CONTRACT ID NO. 101338

ADDENDUM # 2

Pike County, APD 80-6 (27) Subject:

(1) Revised - Plan Sheets - R2a, R2c, R2e, R2f, R5, R8, R13, R14, R18a, R27,

⚠ REVISED 11-15-10

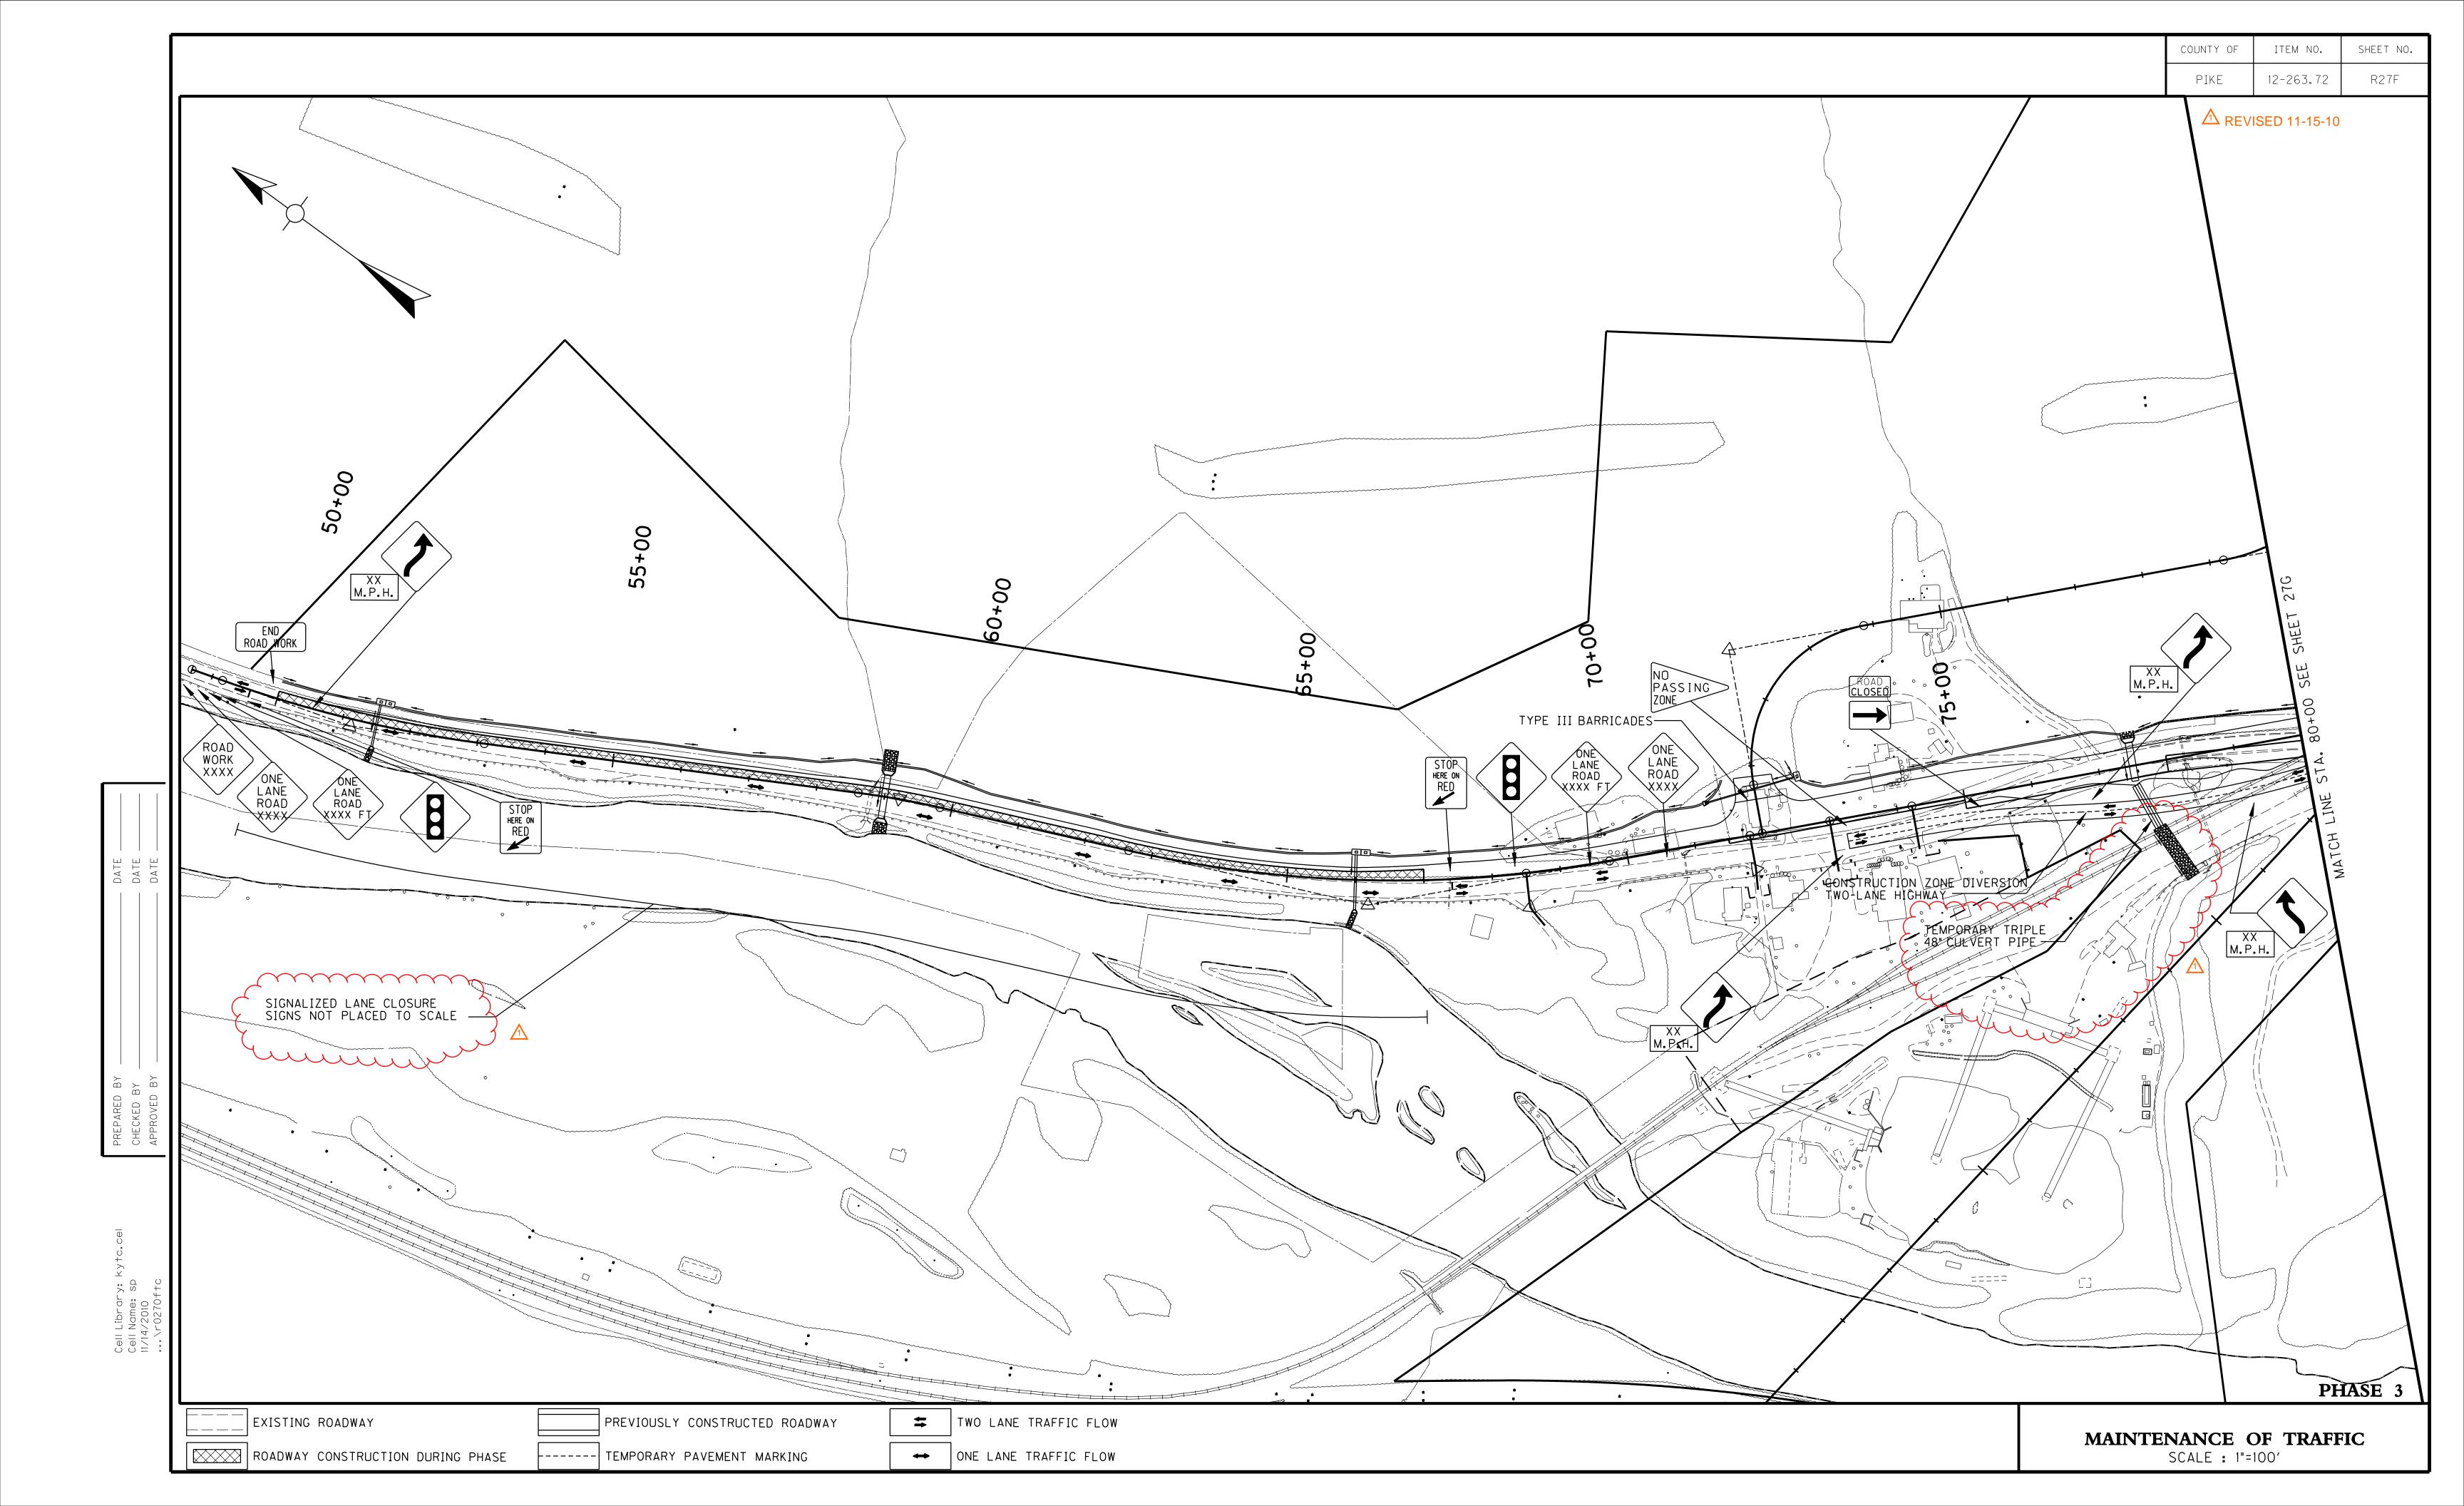
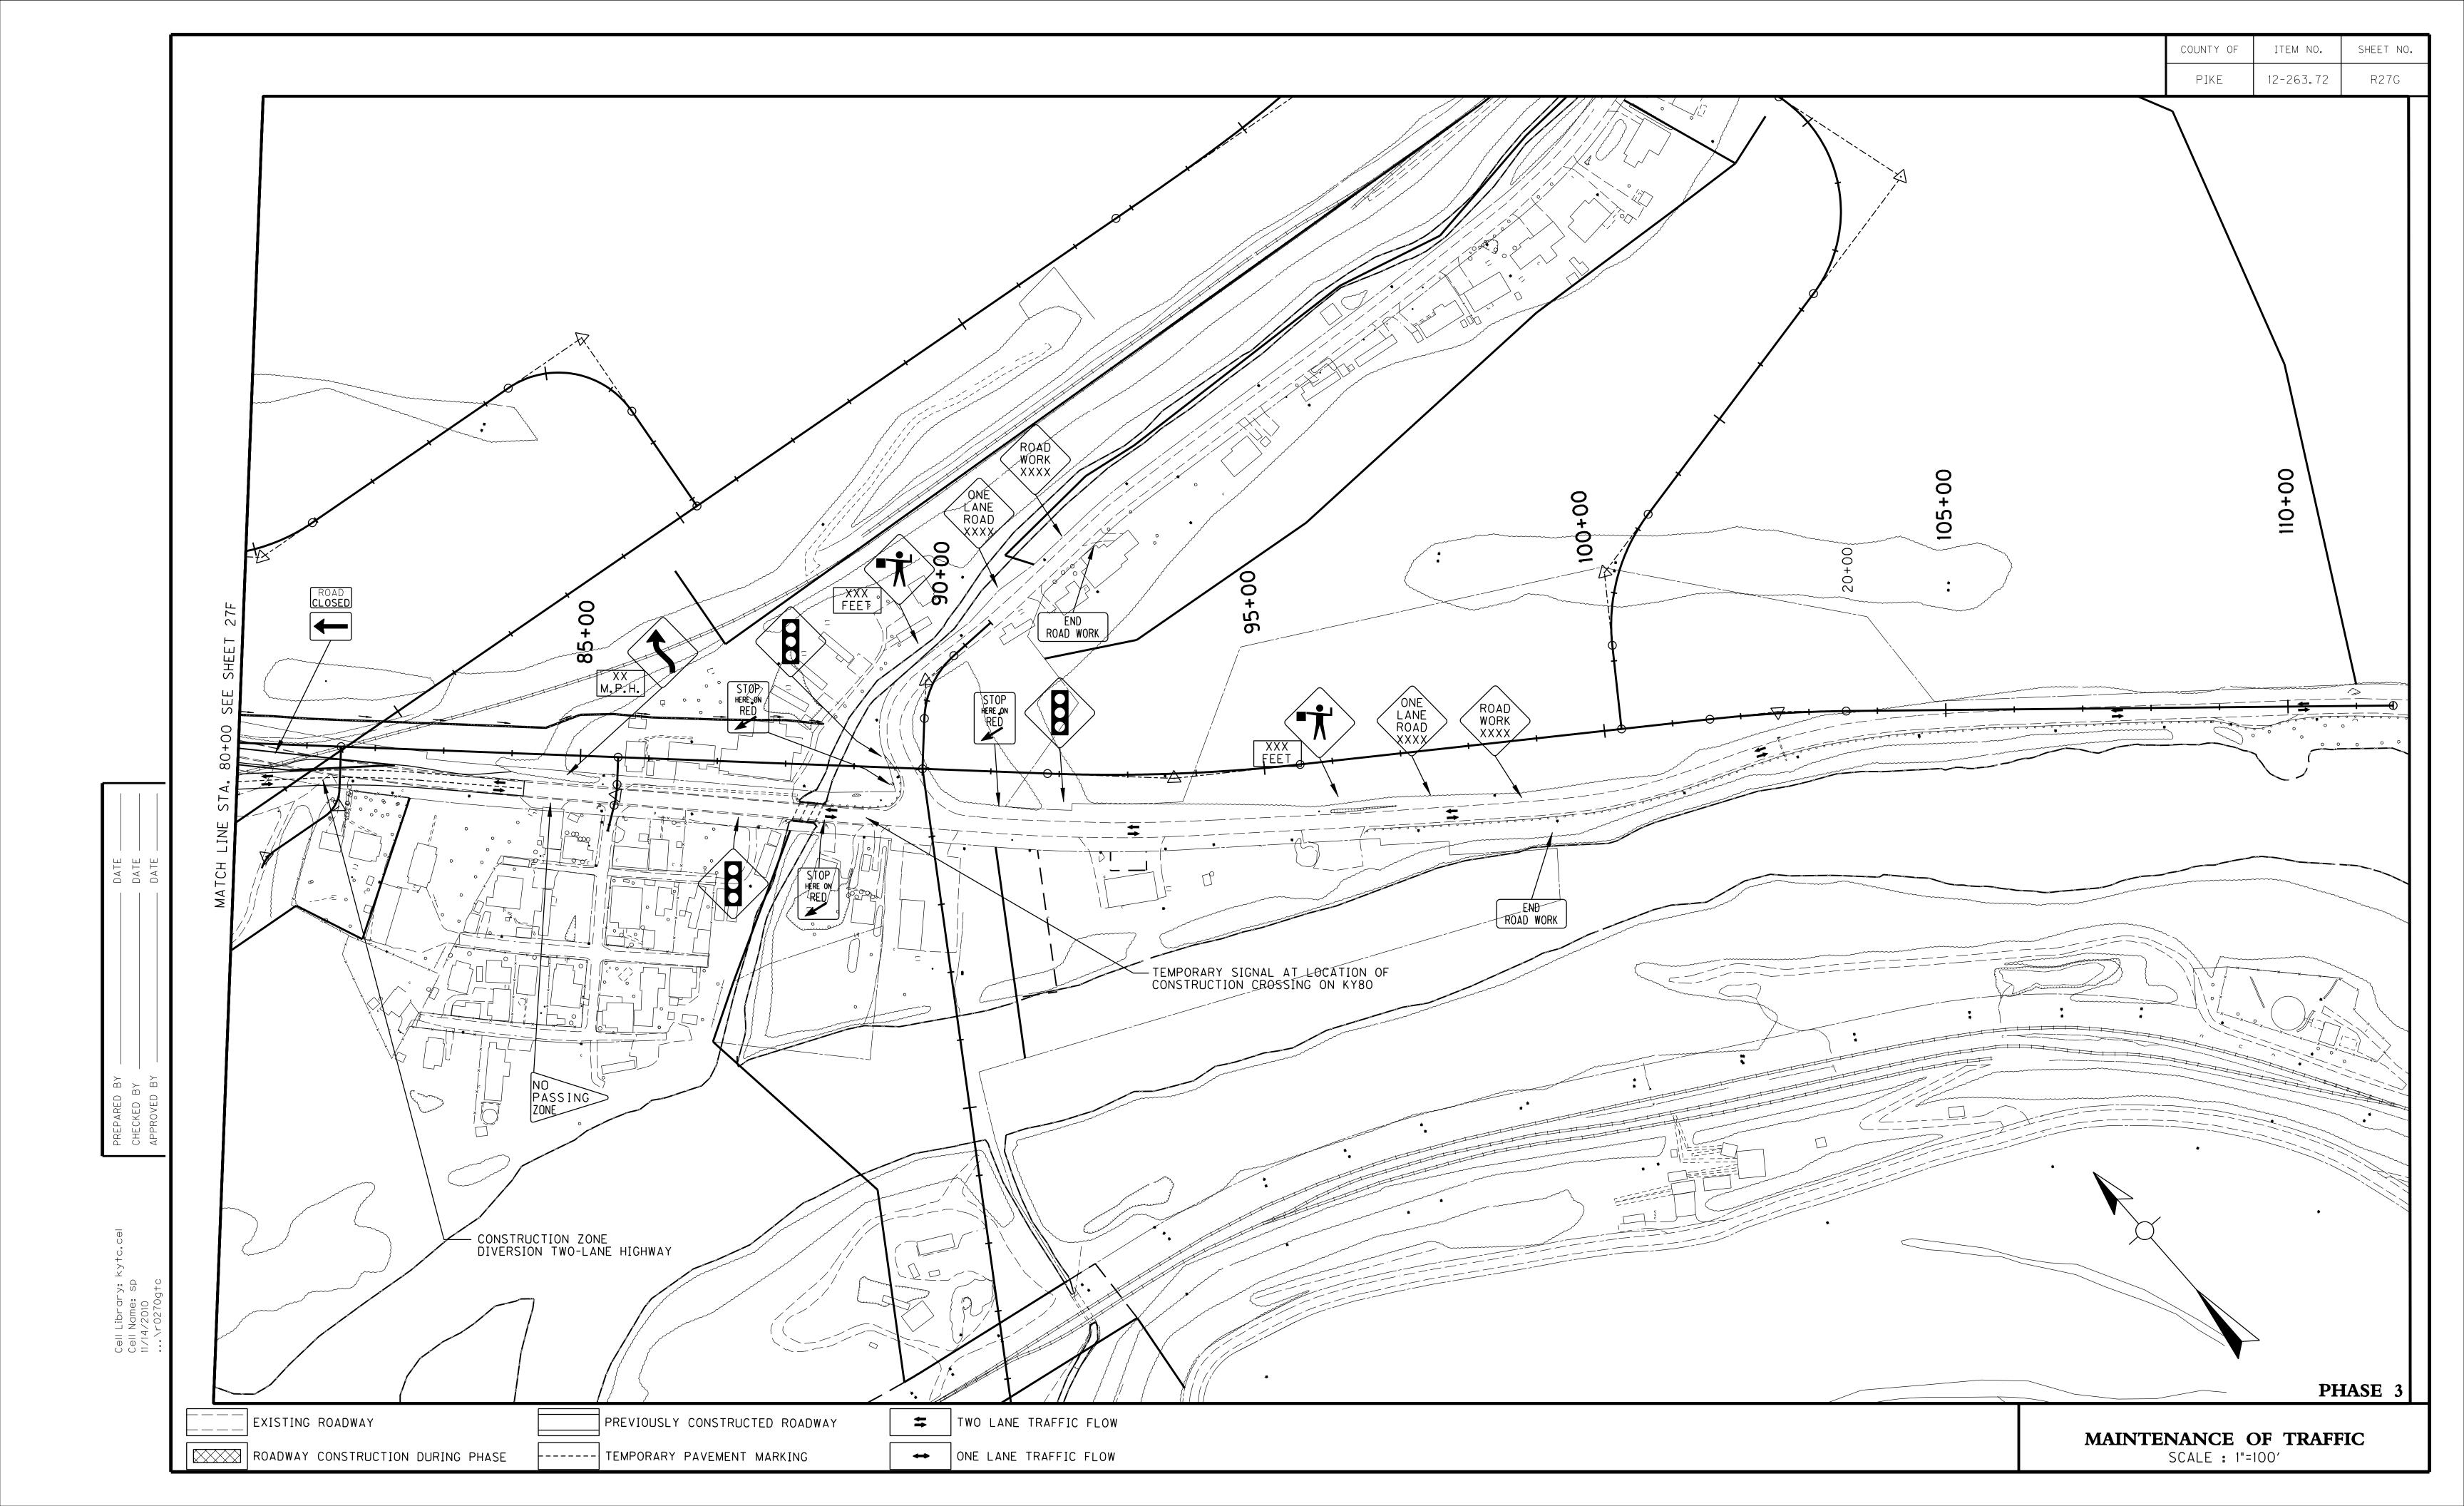
- 20. Any mine tunnels or horizontal auger openings in mined-out areas below grade <u>which show signs of subsidence</u>, whether shown on the plans or not, shall be thoroughly investigated at the direction of the Engineer by rock coring, probing or other means. The openings shall be collapsed or undercut and backfilled with broken stone (durable sandstone or durable shale - SDI 95 or greater) from roadway excavation. The material shall be backfilled in accordance with Section 206. At the direction of the Engineer, pneumatic backstowing of crushed stone (maximum size 40 mm with no more than 5% passing the No. 100 sieve) may be utilized to backfill openings which are inaccessible or difficult to backfill by other means. If feasible, positive drainage of the tunnels or openings shall be provided through use of pipe underdrains or other suitable drainage features. Pipes and other materials used for drainage shall be paid for at the unit bid price for those items. Pneumatic backstowing or other special equipment shall be paid for at the unit bid price per ton of backstowed material. Potential mine tunnels or horizontal auger openings in mined out areas below grade have been identified within the following station interval.

21. Any mine tunnels or horizontal auger openings which are exposed in cut slopes, whether shown on the plans or not, shall be backfilled a minimum distance of 20-feet from the face of the cut. Pneumatic backstowing with broken stone (durable sandstone or durable shale - SVI 95 or greater, maximum size 40 mm with no more than 5% passing the No. 100 sieve) shall be required in an effort to completely fill any voids. The last five (5) feet, horizontally, of backstowed material shall contain five percent cement, by weight, and shall be backstowed as a slurry mix. If feasible, positive drainage of the tunnels or openings shall be provided through the use of pipe underdrains, surface ditches or other suitable drainage facilities. Pipes and other material used for drainage shall be paid for at the unit bid price for those items. Pneumatic backstowing and other materials, or special equipment, shall be paid for at the unit bid price per ton of backstowed material. Potential mine tunnels or horizontal auger openings which may be exposed in cut slopes have been identified within the following station interval.
